Answers to questions raised by Panel Members in response to supplementary report and draft conditions:

## **APPENDIX “A”**

### **Recommended Amended Conditions of Consent**

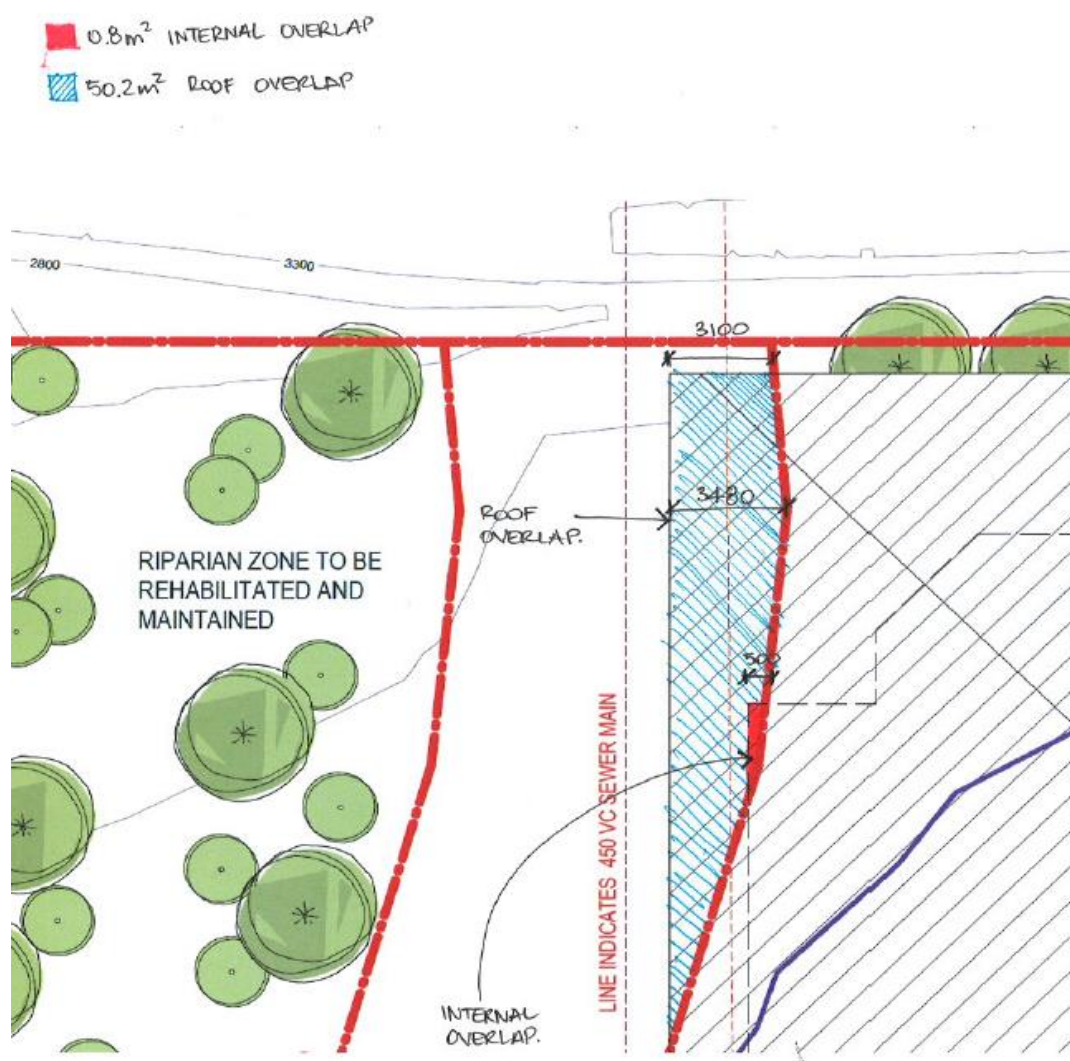
- The Supplementary Report indicates that Council has had further consultation with the Office of Water who clarified that a 30m riparian zone is to be established. Could you please ask Council to confirm whether the proposed revised conditions in relation to this aspect of the application takes this requirement into account. As part of the proposed building encroaches into what was to a landscape zone which is now to be a riparian zone does this have any affect on the plans before the Panel or is Office of Water consenting to such encroachments, with a controlled activity permit still to be obtained in the future? I am just not clear on whether the change in advice provided by Office of Water has any impact on the plans before us - is there certainty regarding the proposed design in this respect?*

Consultation with DPI Water in this regard was undertaken prior to the JRPP meeting on 8 December 2016. The officer at DPI Water was advised of Councils intention to impose a condition of consent requiring all of the area within the 30m setback from the creek to comprise riparian vegetation, which they have advised in writing is supported. DPI Water had also been sent (prior to the JRPP meeting) the plan that is copied below which illustrates the building encroachment into the 30m zone.

It is recommended that Condition No's.20 & 30 be amended as follows to provide clarity in this regard and to require amendment to the landscape plan (that shows the last 10m of the riparian setback as being turfed).

Native vegetation is to be retained and rehabilitated within **the entirety of** the 30m riparian buffer to South Creek (from top of creek bank) in accordance with the approved Vegetation Management Plan (VMP). ~~and illustrated on the approved landscape plans, with the area to be rehabilitated to be clearly defined from the developed area.~~

**The area to be rehabilitated shall be clearly defined from the developed area with** the extent of the **30m** Vegetated Riparian Zone (VRZ) **shall to be** demarcated **on site** by the concrete pathway as shown on the '*Landscape Masterplan Ground and Entry plan*' (Dwg.1100). All planting to the south of this pathway shall comprise riparian vegetation (not turfed) with signage provided to clearly indicate that this area should not be traversed.

**The Landscape Plans, Drawing No.1100 (Issue D) '*Landscape Masterplan Ground and Entry*' shall be amended to reflect the requirements of Condition No.20 of the consent, for the entirety of the 30m buffer to South Creek to comprise riparian vegetation (not turf). The amended plan shall be included in the plans submitted to the Principal Certifying Authority with the application for a Construction Certificate.**
